City of Burlingame

Meeting Minutes Planning Commission

- d. 619-625 California Drive, zoned C-2 (North California Drive Commercial District) - Environmental Scoping for Lot Merger, Design Review, Conditional Use Permit for building height, and Condominium Permit for construction of a new, four-story, 26-Unit live/work development (Ellis A. Schoichet, AIA, applicant and architect; Ed 1005 BM LLC, property owner) (101 noticed) Staff Contact: Ruben Hurin

ARCHITECT'S SUMMARY and RESPONSE

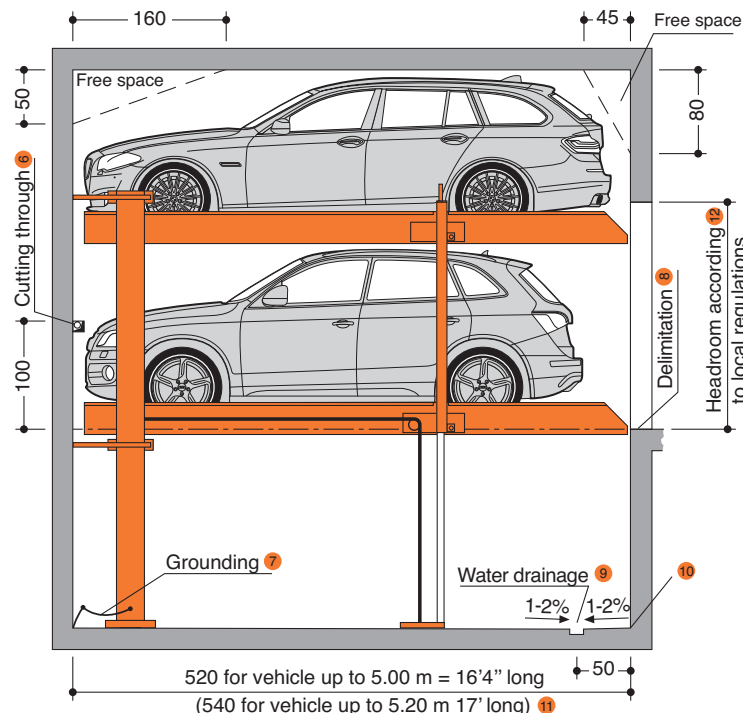
14. The First Floor level of the California Street façade has been significantly redesigned, especially the way the architectural treatments at the First Floor interpenetrate and integrate with the treatment at the floors above. Modest changes have been implemented across the rest of the building,

refinements to the previous design. The palette of (6) different color rain-screen panels, architectural concrete, as well as decorative metal gates and grille work remains as before.
